Parts Technical Information

MODELS: Coupe & Convertible

SUBJECT: Door locks

SUBJECT: Reinforcement-Handle Aperture Door

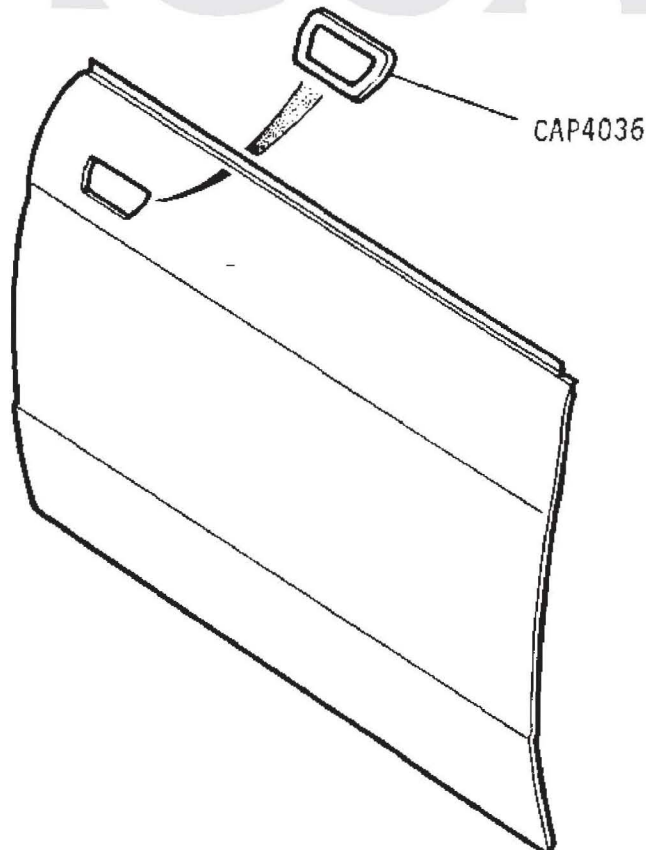
Replacement Door Assemblies and Outer Door Panels are to be supplied without the reinforcement for the Door Handle aperture. The "Cathodic" paint process for electrocoat primer application, requires a high paint curing temperature. This temperature adversely affects the adhesive which is used to secure the reinforcing strip to the Outer Door Panel.

When ordering a Door Assembly or Outer Door Panel the Steel Reinforcing ring- CAP 4036 will also be required. CAP 4036 should be fitted using an approved body sealant to the Door Panel.

SUBJECT: Front Wings

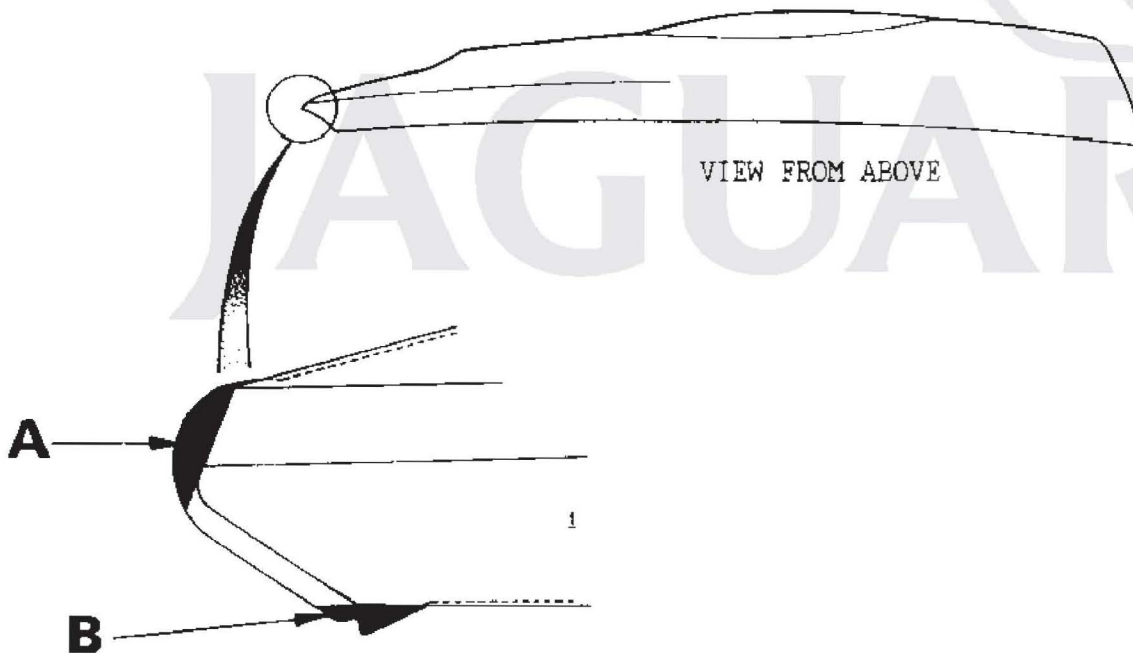
Due to a change in the manufacturing process, future supplies of BHC 1810 and BHC 1811 will have excess metal in the areas shown below.

Metal should be removed from areas A & B to match the profile of existing body panels.

Dress and repaint affected areas to approved Jaguar standard.
